MIL-F-22606B (SHIPS)
AMENDMENT 6
10 August 1977
SUPERSEDING
AMENDMENT 5
17 July 1974

MILITARY SPECIFICATION
FLASK, COMPRESSED GAS, AND END PLUGS;
FOR AIR, OXYGEN, AND NITROGEN

This amendment forms a part of Military Specification MIL-F-22606B (SHIPS), dated 12 June 1964 and is approved for use by the Naval Sea Systems Command and is available for use by all Departments and Agencies of the Department of Defense.

FIGURE 1. Plugs for "O" ring assembly.

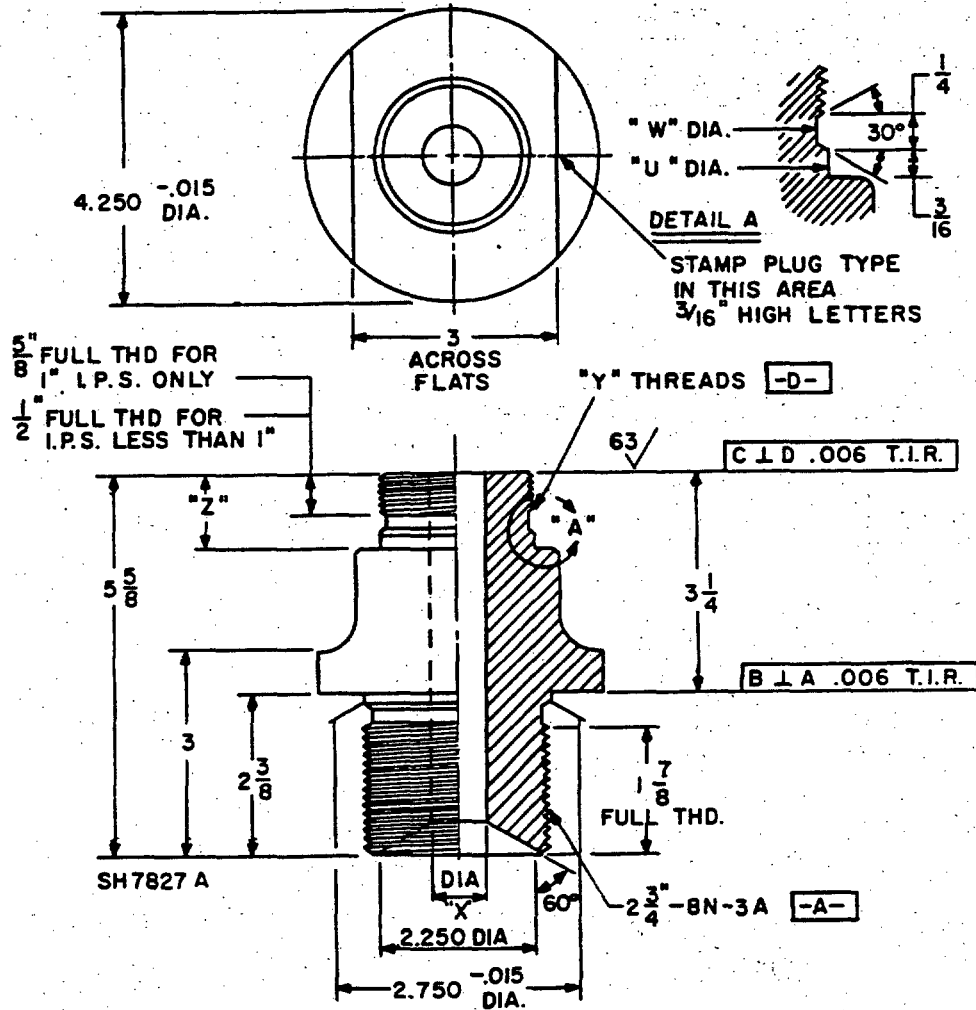
Figures 1, 2, 4 and 9: Delete and substitute attached figures 1, 2, 4, 8A and 9.

FIGURE 8A. Impulse flask.

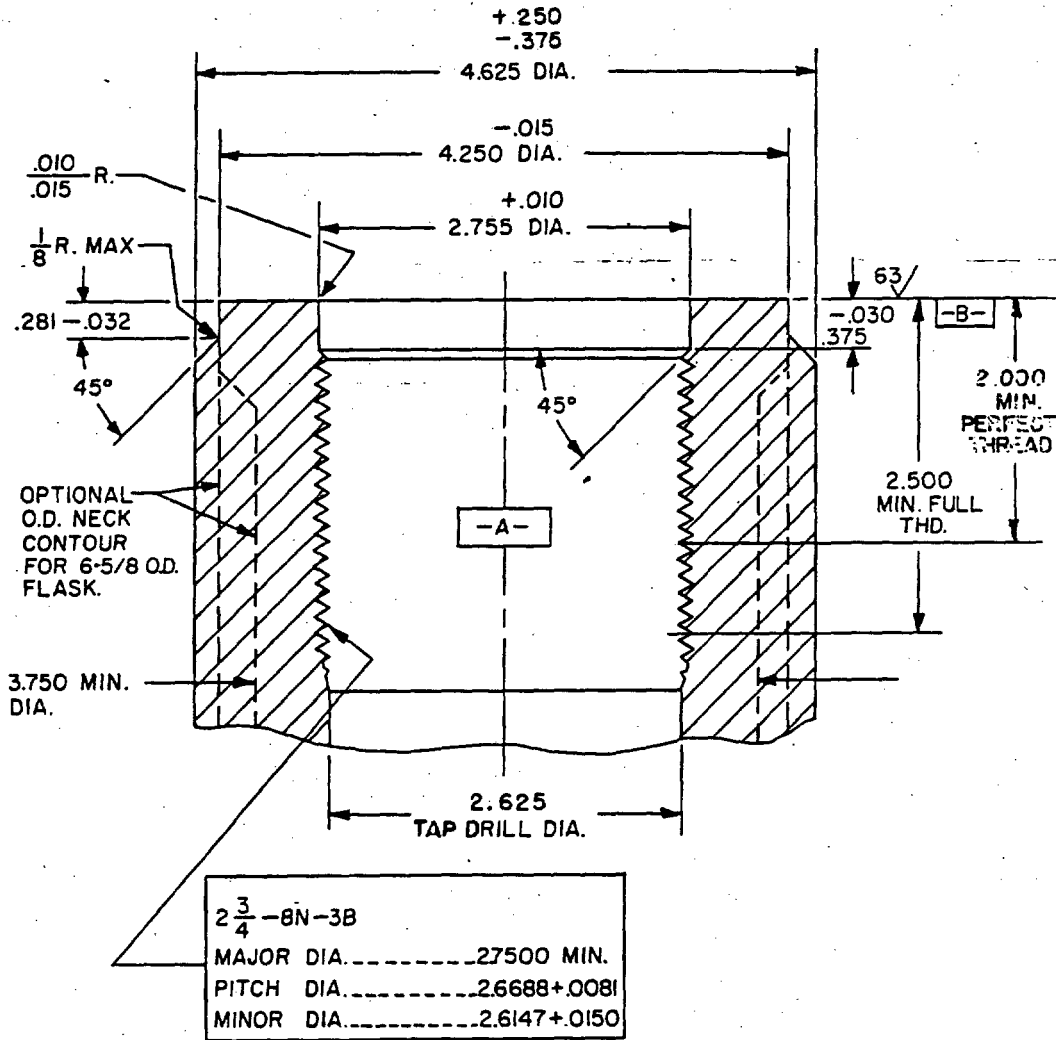
"3.3.1.1 Impulse flasks for diesel propelled submarines shall conform to the characteristics and dimension of figure 8A, when required."
